JRPP PLANNING REPORT

JRPP NO:	2010 SYW083
DA NO:	704/2011/JP
PROPOSED DEVELOPMENT:	PROPOSED SUPERMARKET AND ASSOCIATED WORKS
SUBJECT SITE:	LOT 1 DP 528019 AND LOT 37 DP 38439 NO. 73 – 75 WINDSOR ROAD, BAULKHAM HILLS
APPLICANT:	TPG NSW PTY LTD
LODGEMENT DATE:	15 NOVEMBER 2010
REPORT BY:	KRISTINE MCKENZIE PRINCIPAL EXECUTIVE PLANNER
RECOMMENDATION:	REFUSAL OF THE DEVELOPMENT APPLICATION

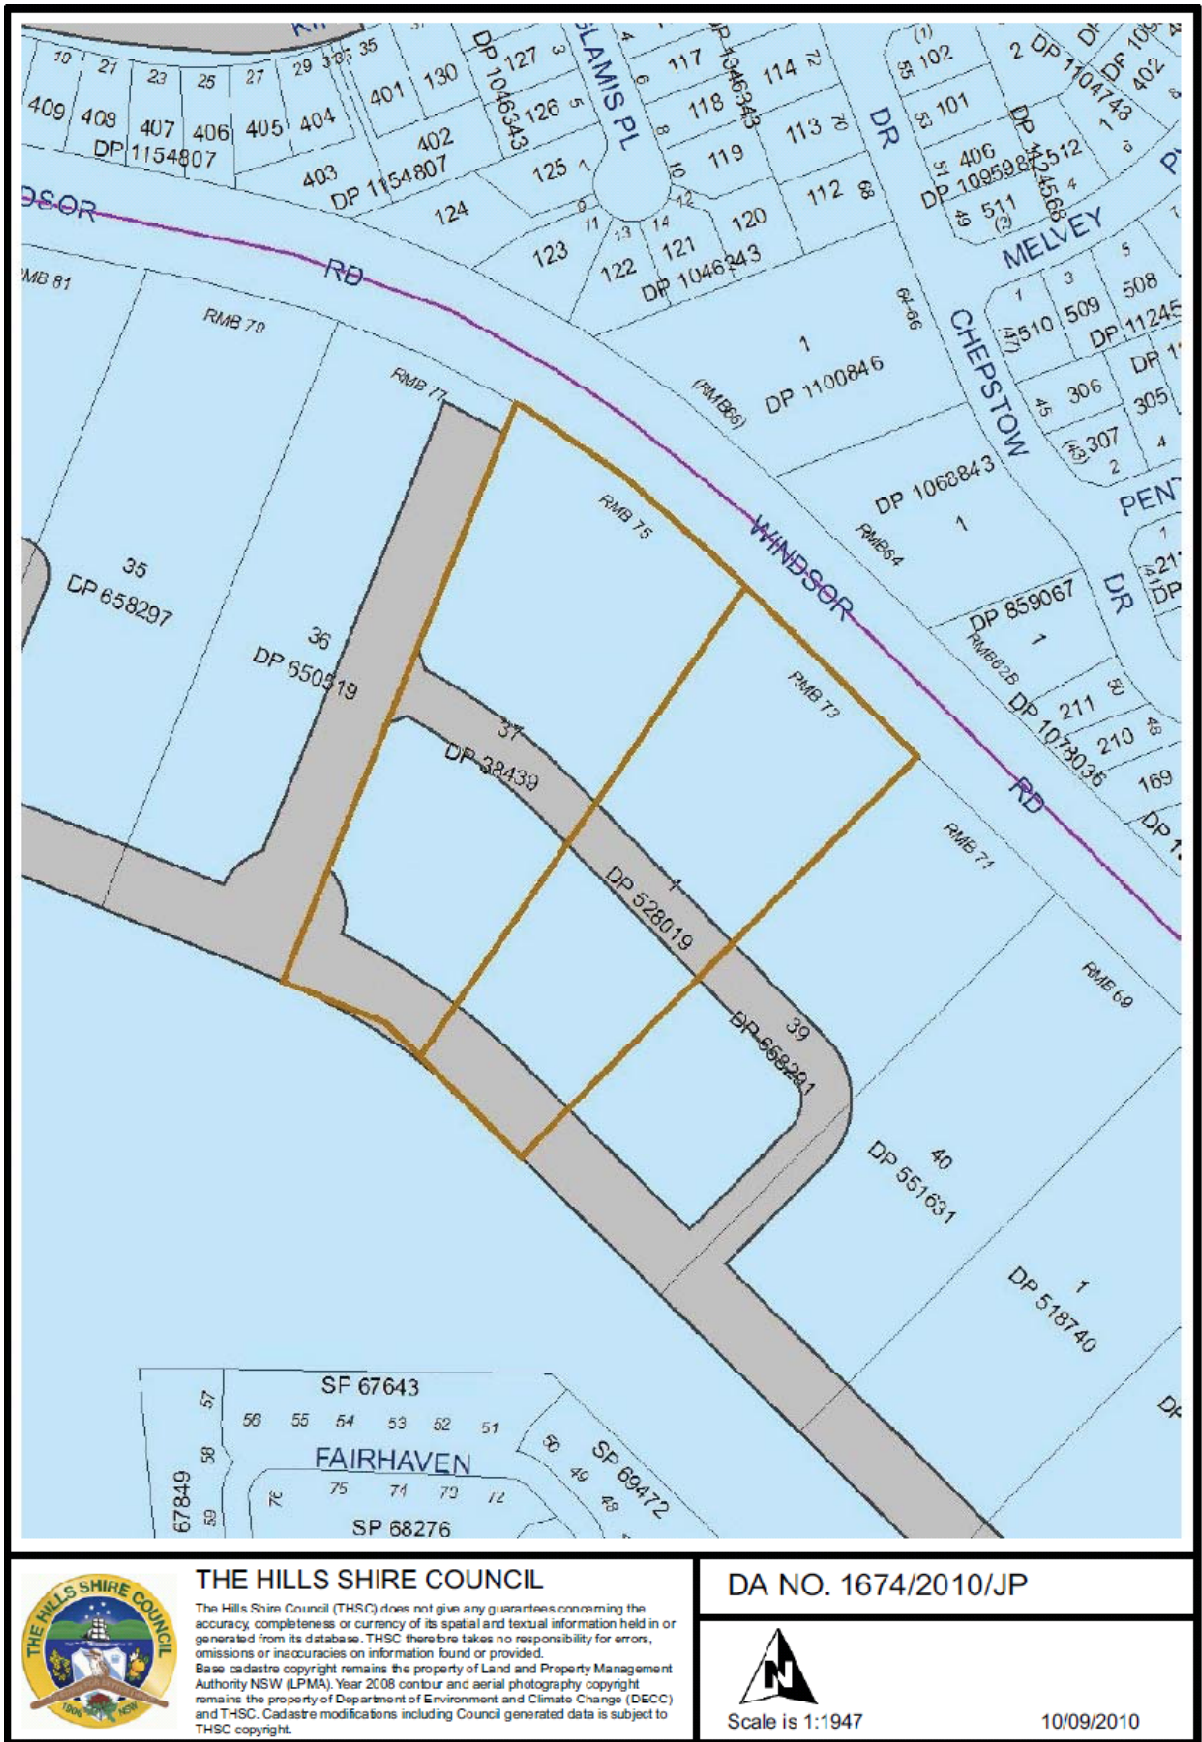
The subject site is located within the Balmoral Road Release Area. The area was rezoned from rural land to predominantly residential land on 13 April 2006. Development Control Plan Part E Section 17 – Balmoral Road Release Area contains the relevant standards for development within the area and includes a proposed road layout plan. A copy of the proposed road layout plan is Attachment 6.

The applicant has proposed to relocate Wager Road from No. 77 Windsor Road to the subject site in order to provide public road access. The adjoining property owner was notified of the Development Applicant however made no submission was received either in support of the proposal or against the proposal.

As the access road (Wager Road) from Windsor Road is located wholly on the adjoining property, the applicant wishes to apply for realignment of the Wager Road to the east, so it is wholly located on the subject site, as part of this development application and given the determination of the JRPP it is considered that providing the access road on the subject site is consistent with the intent of Council's DCP Map in that the access road will provide the same outcomes on the subject site despite not being located in the location indicated by the DCP Map. The applicant's traffic engineer has been liaising with the RTA about the access road connecting to Windsor Road.

The Baulkham Hills Development Control Plan Part E Section 17 Balmoral Road Release Area 4.1 Local Road Hierarchy requires that the street and road network should conform to the pre-planned road layout as shown on the accompanying development control plan map. This plan shows vehicular access to the site via Stone Mason Drive which runs parallel with Windsor Road and connects residents to Windsor Road, Fairway Drive and Memorial Avenue. Wager Road will also provide direct access to the site via Windsor Road however is limited to a left turn entry and exit. Stone Mason Drive is also accessed from Windsor Road by Spurway Drive which is also proposed to be limited to left in / left out access.

Whilst Council's Traffic Section have raised no objection to the proposal based on road capacity, the development application represents a much larger, more intrusive development than planned at the location. It has the potential to be a greater attractor than is envisaged and is likely to have an adverse impact on the planned road network and surrounding development.

ATTACHMENT 7 – THREATENED SPECIES PLAN

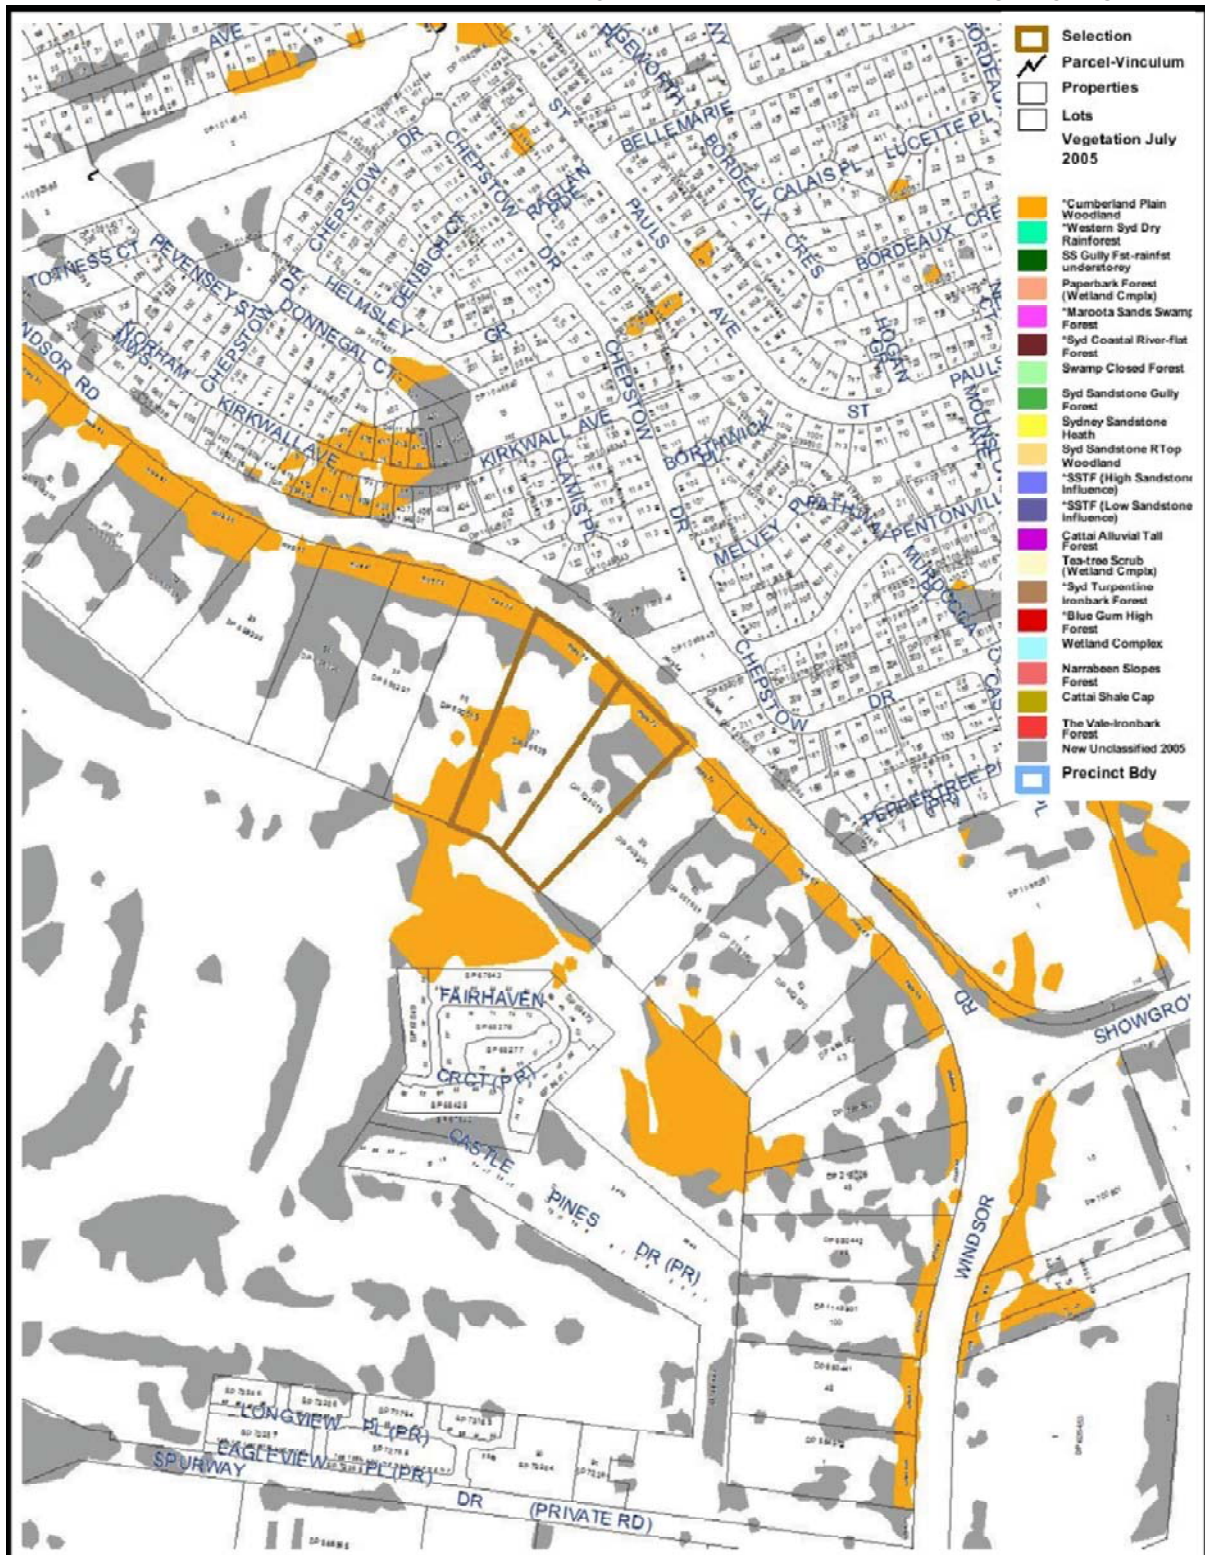
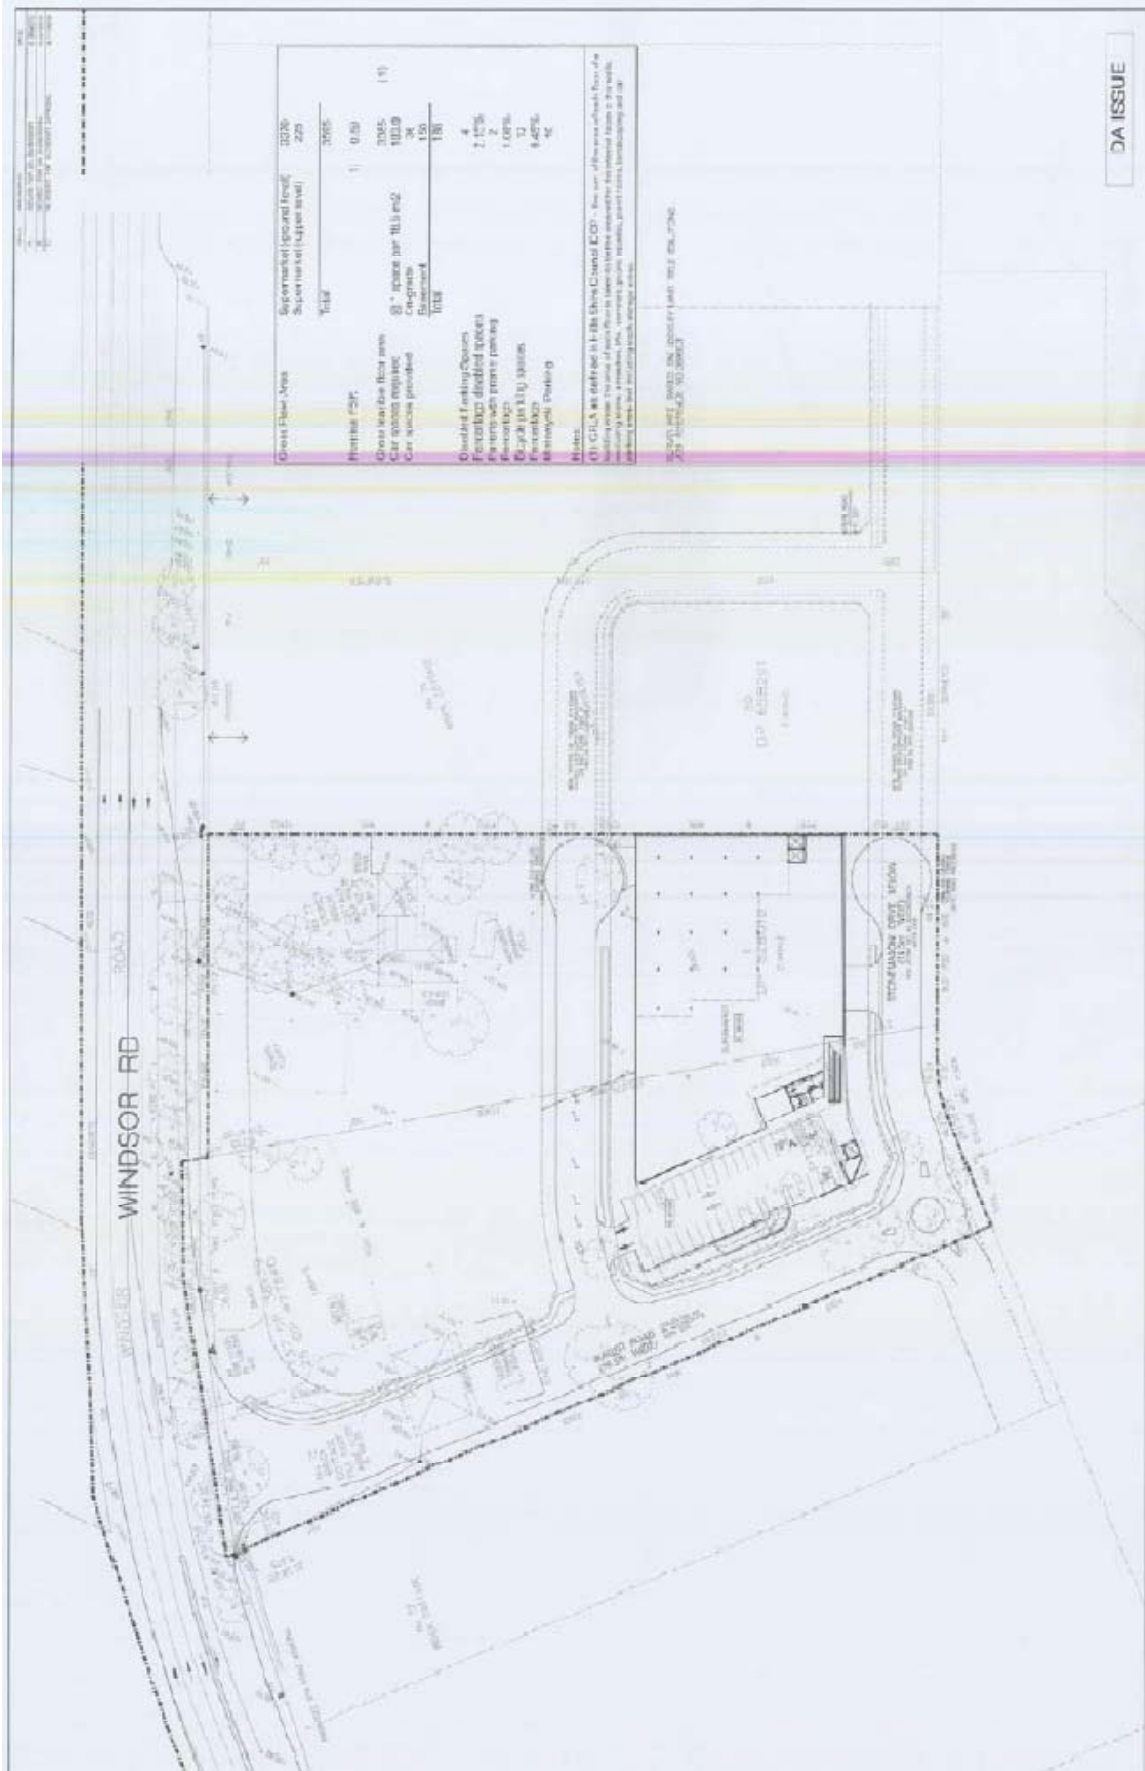
In addition, the proposal also includes removal of Cumberland Plain Woodland which is a Critically Endangered Ecological Community. The removal of the Cumberland Plain Woodland from the site and resultant isolation of Cumberland Plain Woodland on an adjoining site triggers the need for a Species Impact Statement to be undertaken. A Species Impact Statement has not been submitted.

In undertaking an assessment of significance under part 5A of the Environmental Planning & Assessment Act, 1979 the proposal as it stands would remove the CPW on the subject site and further would isolate the attached CPW patch in the adjacent golf course. These two factors trigger the need to prepare a Species Impact Statement for the proposal.
